**Brook Valley Business Park Replat 5**

RECOMMENDATION REPORT

CASE NUMBER: PRP-17-0001

RE: Replat Application – Initial Review  
Brook Valley Business Park Replat 5

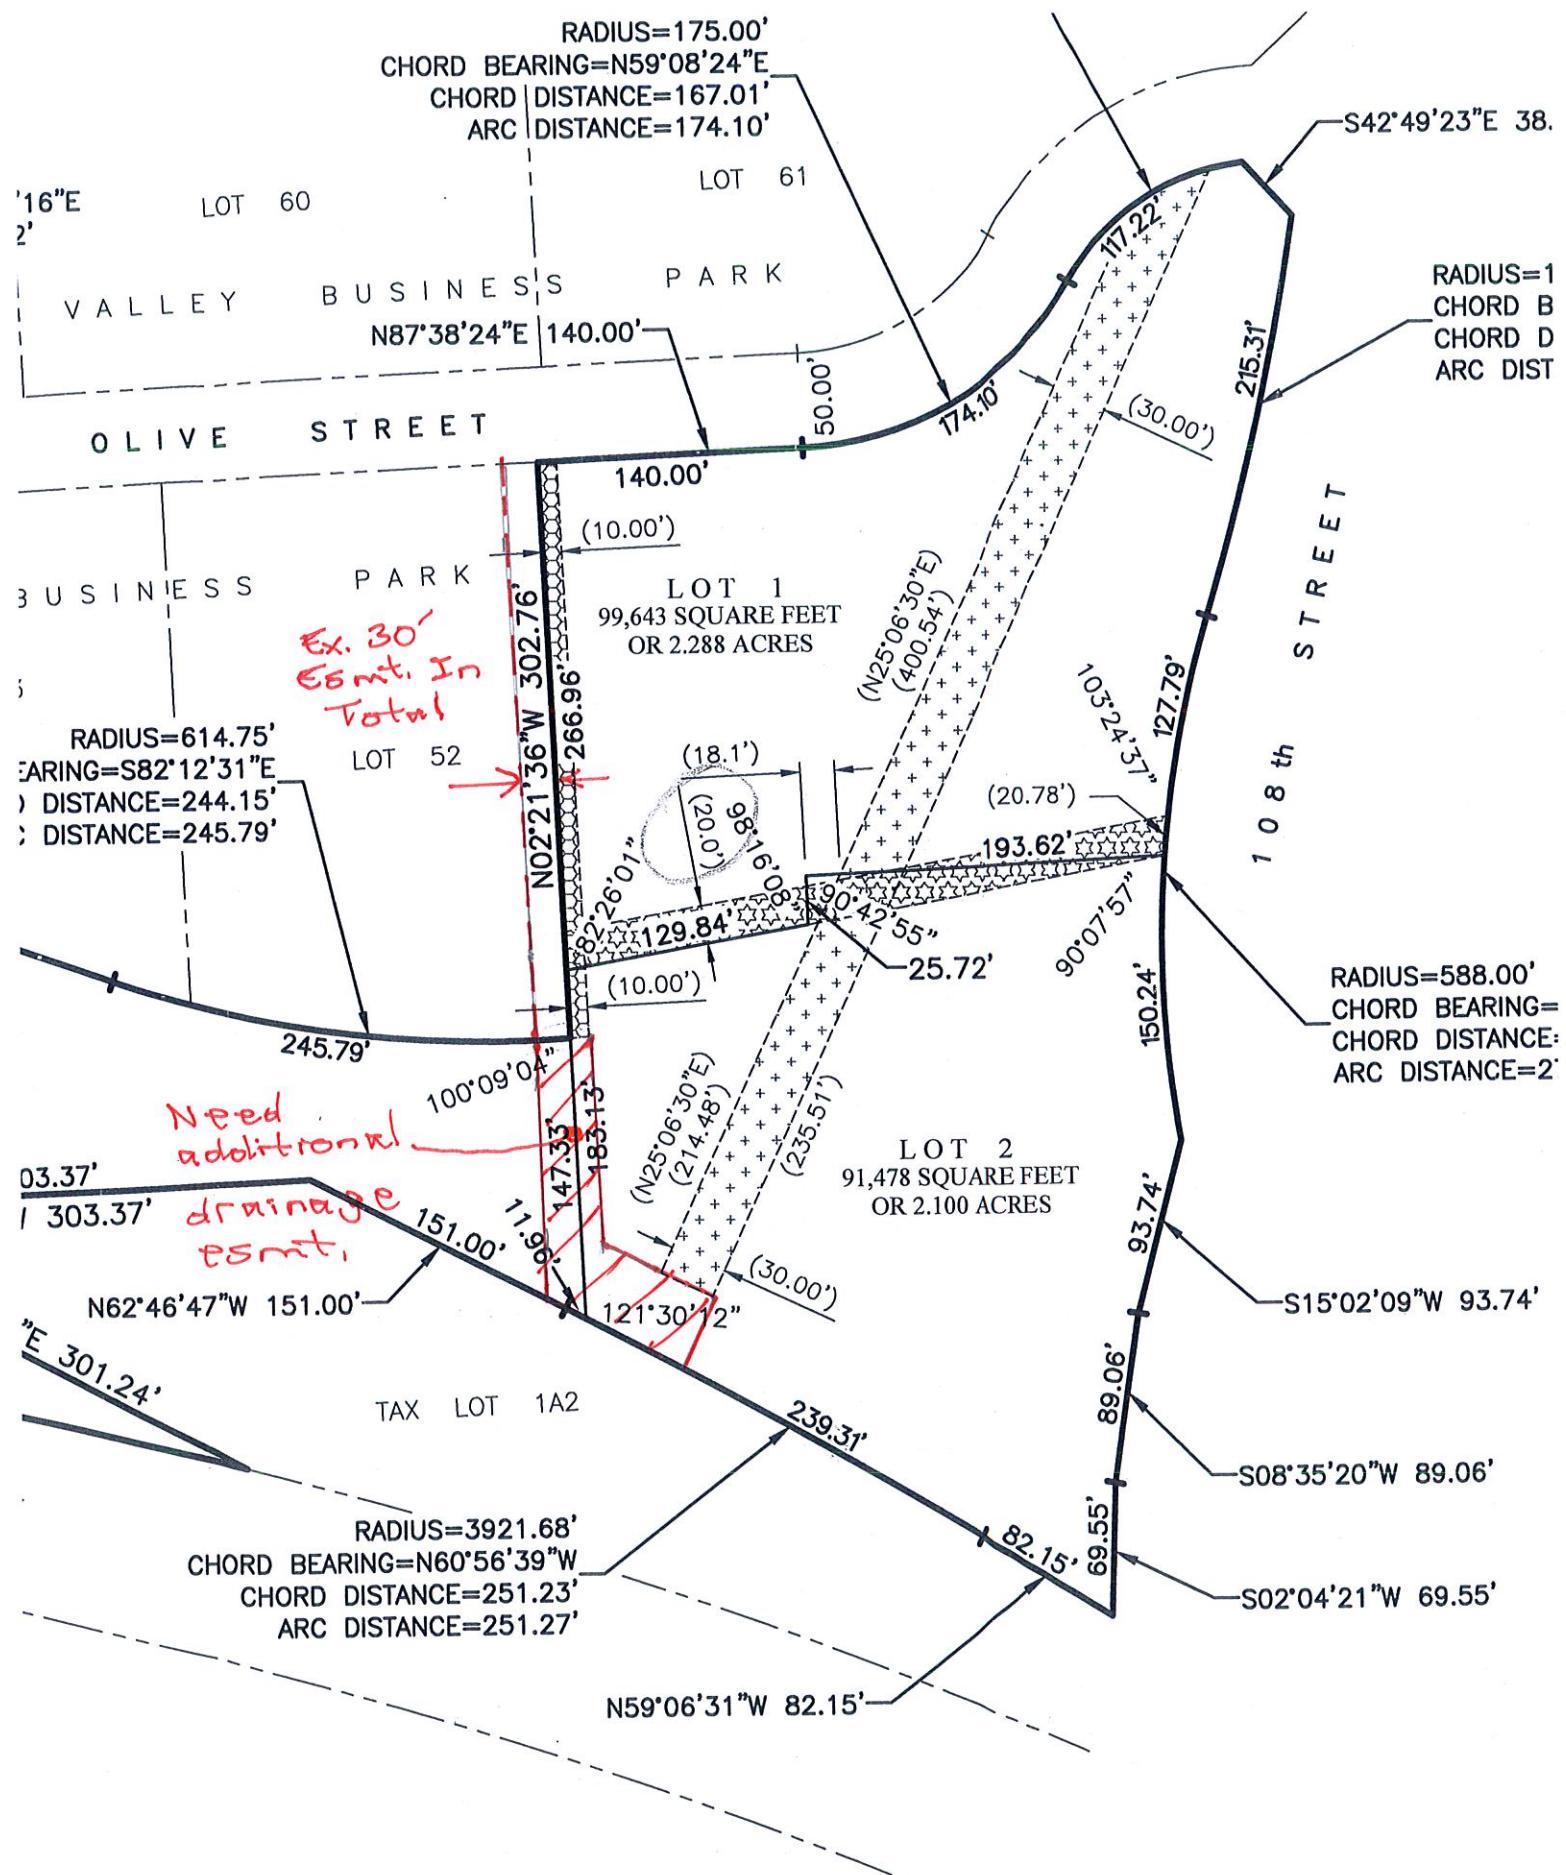
feet on the preliminary plat and 20 feet on the final plat. Also, the extension of the storm sewer easement from the west side of Lot 1 to the south along the common lines of Lots 2 and 3 will need to be at least 30 feet wide which is the existing width in total along the west side of Lot 1, but will be subject to major storm path easement needs. There will need to be closure of the gap between the existing storm sewer easements as noted on the attached excerpt from the final plat.

In response to Item 5: The revised submittal has included consistently showing the easement at 25 feet in width on both documents.
